**TOWN OF OYSTER BAY
BETHPAGE COMMUNITY PARK
INTERIM REMEDIAL MEASURE - CONSTRUCTION AREA**

ADDENDUM TO THE REMEDIAL ACTION PLAN

MARCH 2006

APPENDIX A February 10, 2006 NYSDEC IRM Remedial Action Plan Comment Letter
and March 14, 2006 H2M Partial Response Letter

FIGURE 2

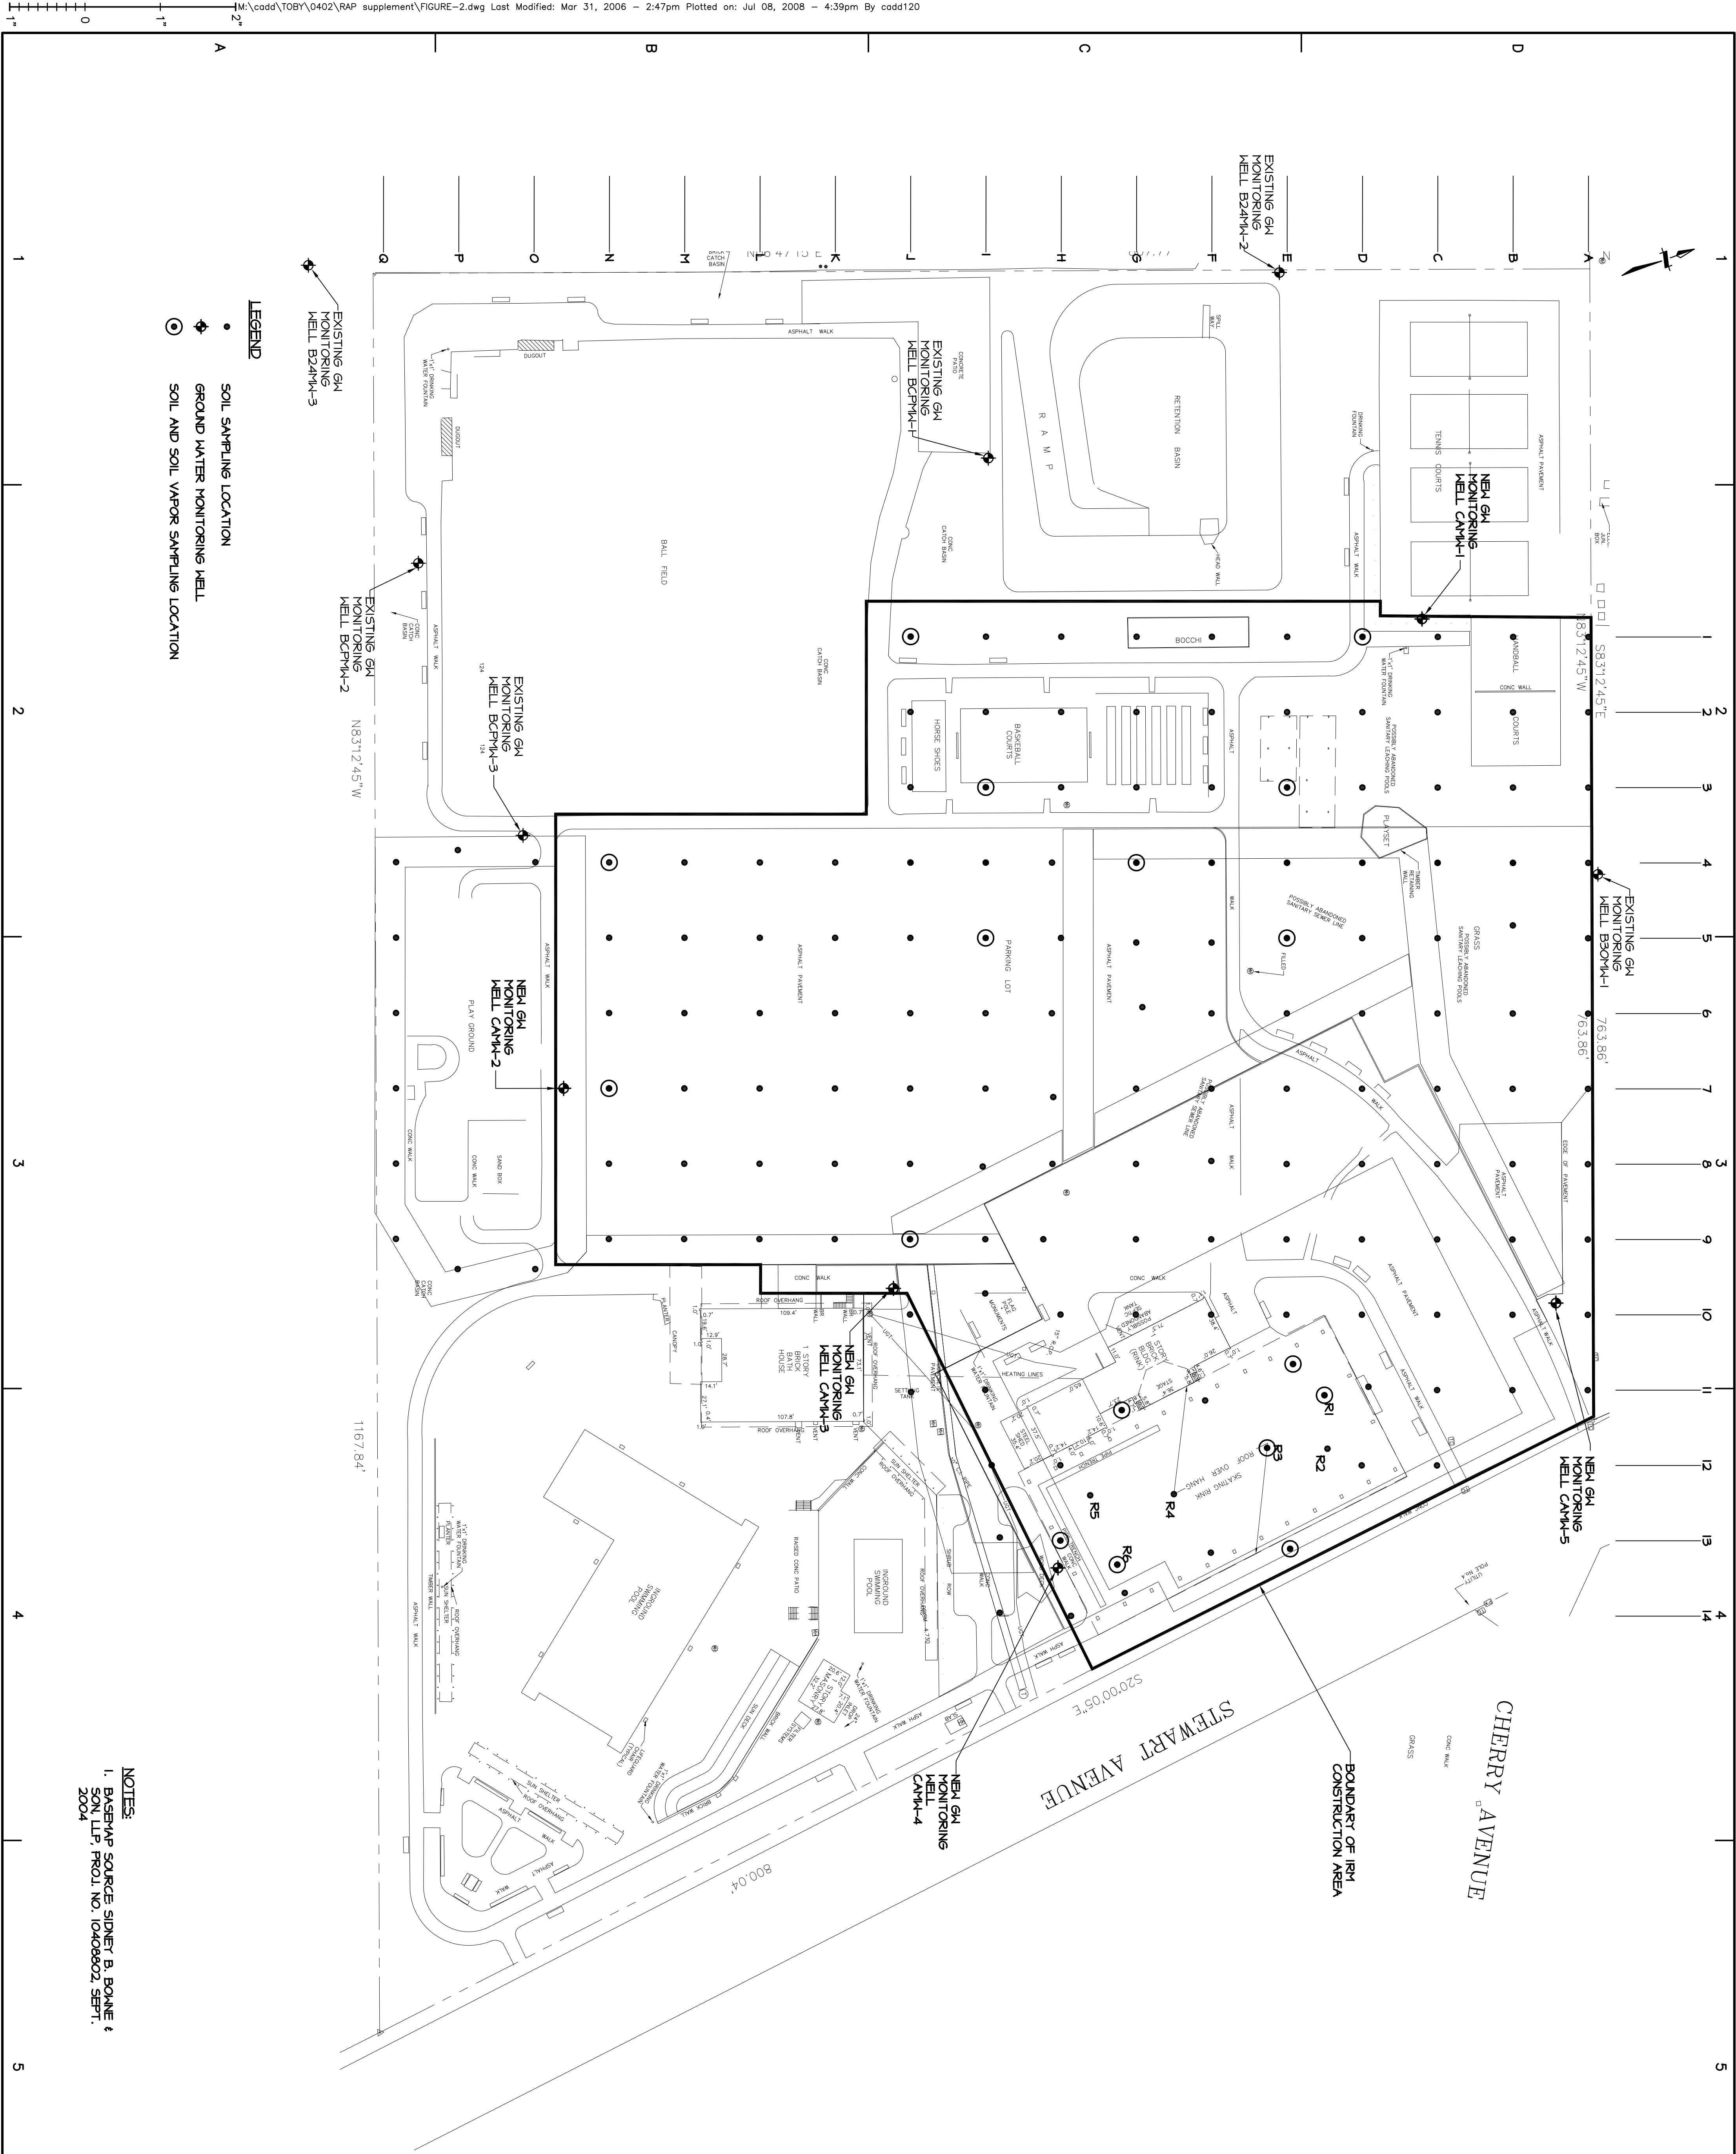
10. Site figures: Soil gas sample locations are not depicted on any figures. These sample locations should be added to appropriate figures of the IRM report and the supplemental sampling report.

FIGURE 4

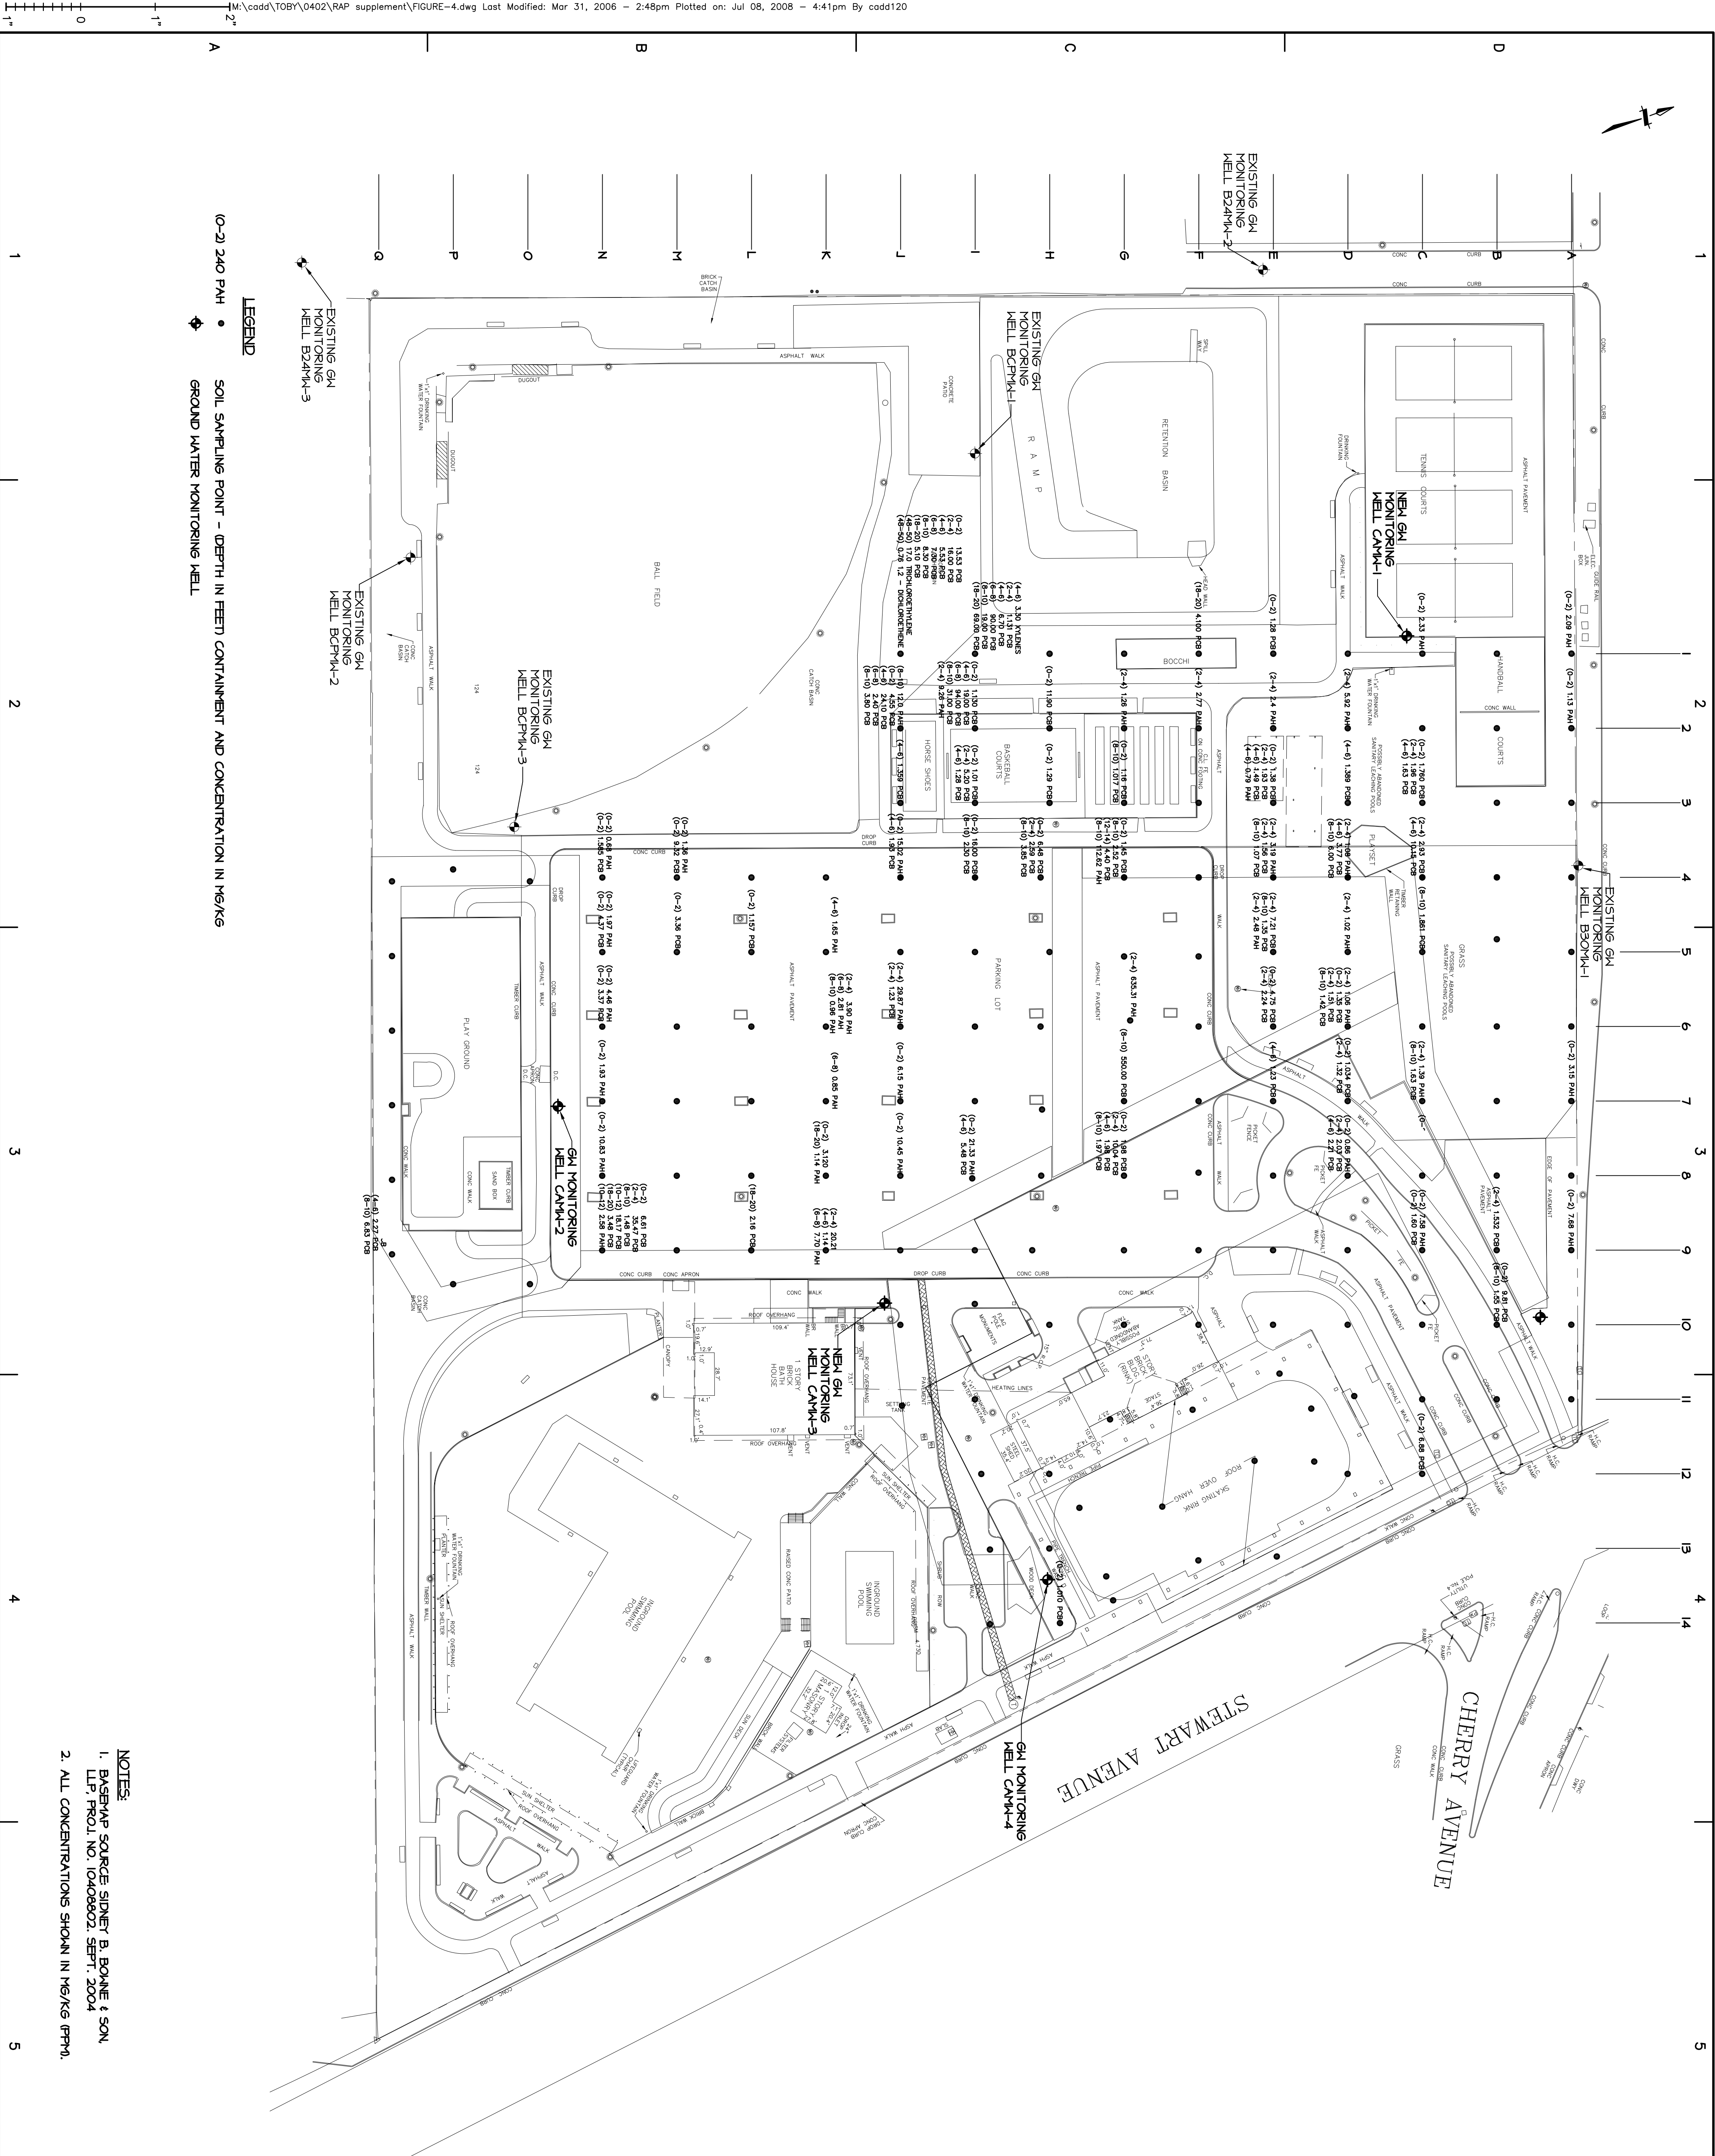
2. Page 10, Third Paragraph: Figure 7 referencing PCBs exceedences should read figure 6 here and in all text locations.

Comment 2 - Page 10, Third Paragraph: Figure 7 referencing PCBs exceedences should read figure 6 here and in all text locations.

Response to Comment 2: The figure number will be changed in the addendum to the Remedial Action Plan.
